Re: 34 Robin St

BUILDING PERMIT REPORT

SITE PLAN REVIEW

**CITY OF PORTLAND, MAINE
SITE PLAN REVIEW (ADDENDUM)
CONDITIONS OF APPROVAL**

PROPOSED SITE PLAN

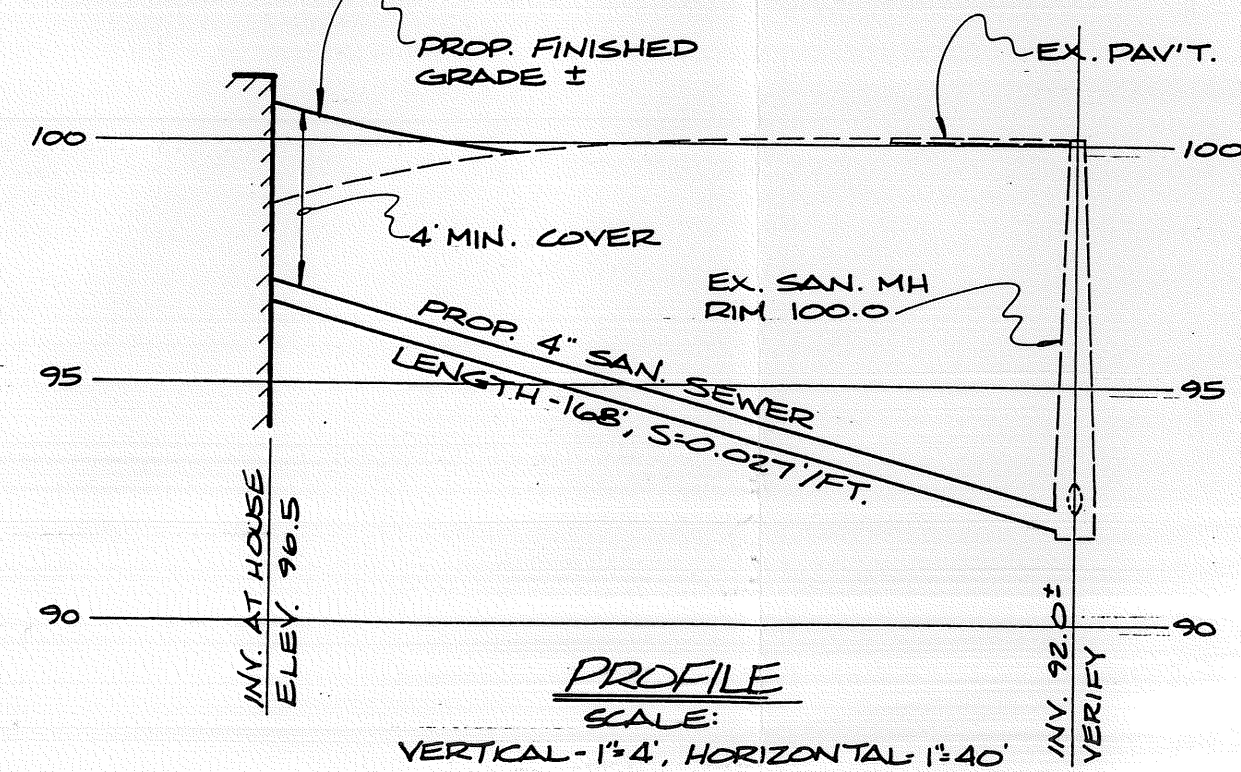
- A sewer permit is required for your project. Please notify Paul Niehoff at 874-8300 ext 8838. The Sewer Division of Parks and Public Works (Jackie Wurslin at 797-5302) must be notified five (5) working days prior to sewer connection to schedule an inspector for your site.

- As-built record information for sewer and storm service connections must be submitted to Parks & Public Works Engineering Division (55 Portland St.) and approved prior to issuance of a Certificate of Occupancy.

- A street opening permit(s) is required for your site. Please contact Carol Poliskey at 874-8300, ext. 8822. (Only excavators licensed by the City of Portland are eligible).
-
